Addendum No. 6, July 11th, 2025

Re: Johnson Hall Renovation – PKG 3
Johnson Hall Renovation & Foster Demolition
Tennessee Technological University
SBC Project No. 364/011-04-2022CM

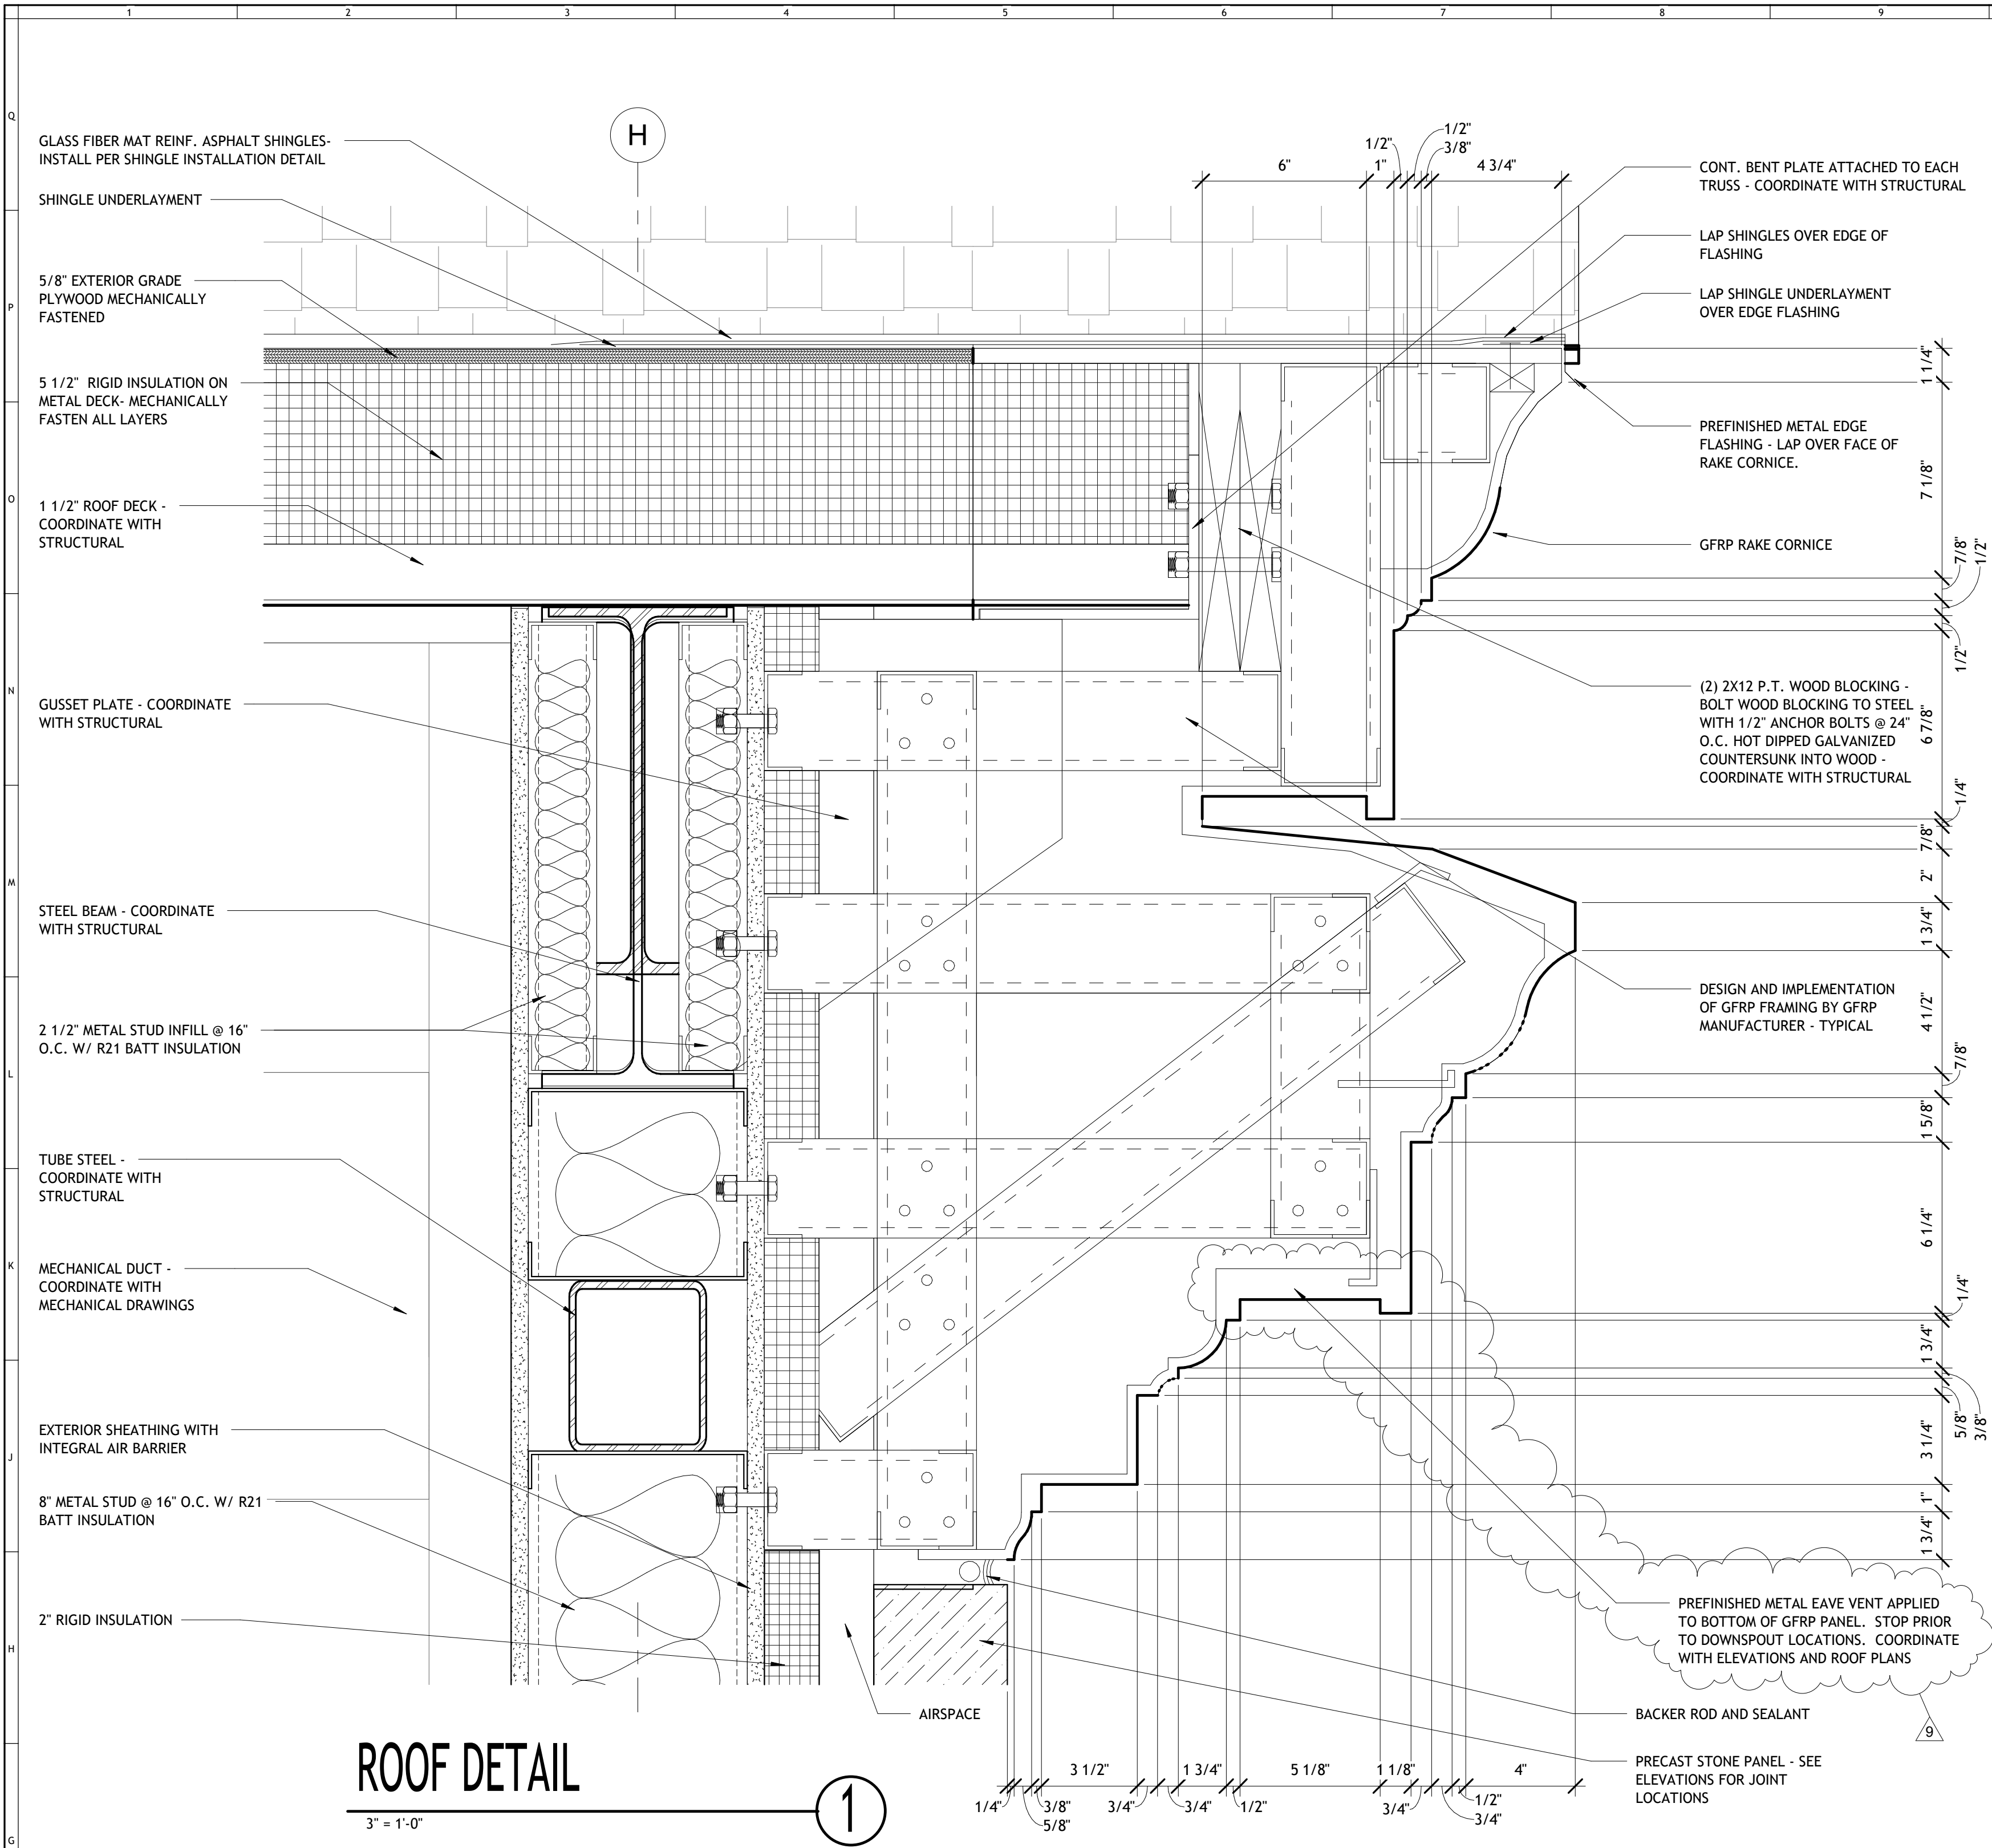
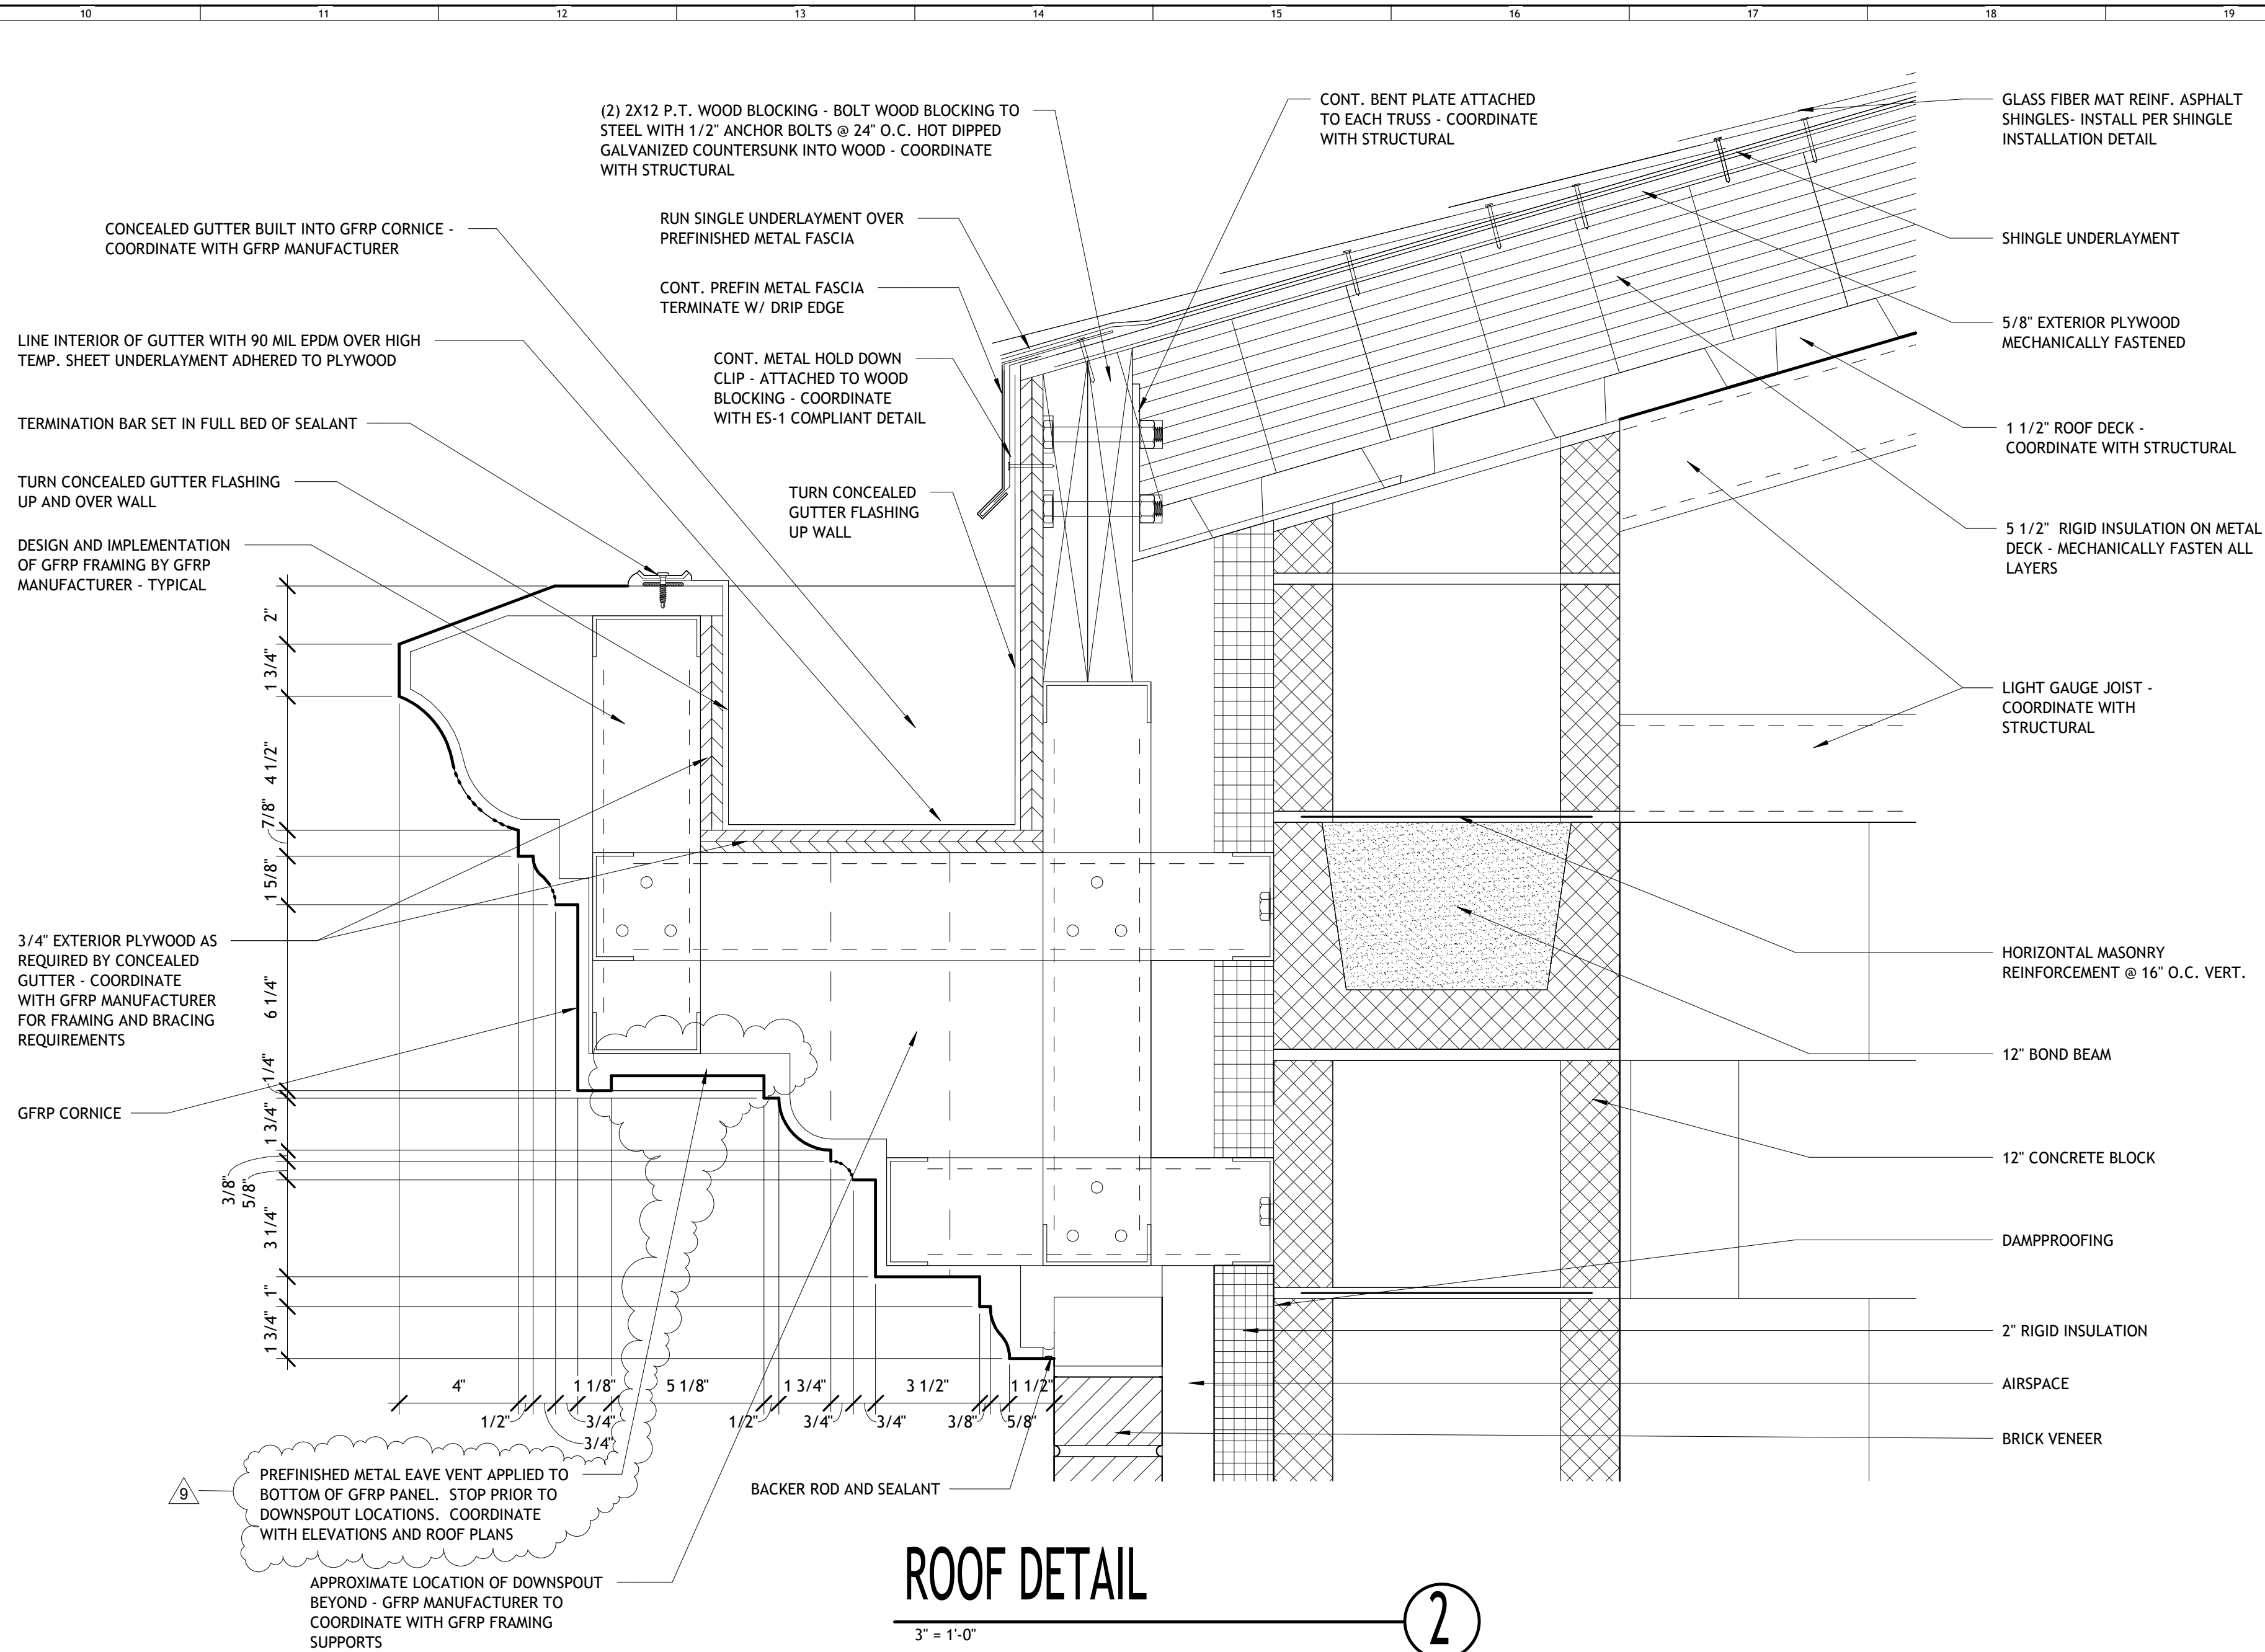
- 12) Refer to sheet A4.22 details 1 and 2. Change portico material to cement plaster on metal lath over 5/8" exterior sheathing board.
- 13) Refer to Sheets A5.12, A5.13, A5.14, and A5.15. Add prefinished metal eave vent applied to bottom of GFRP panel to locations shown on revised details.
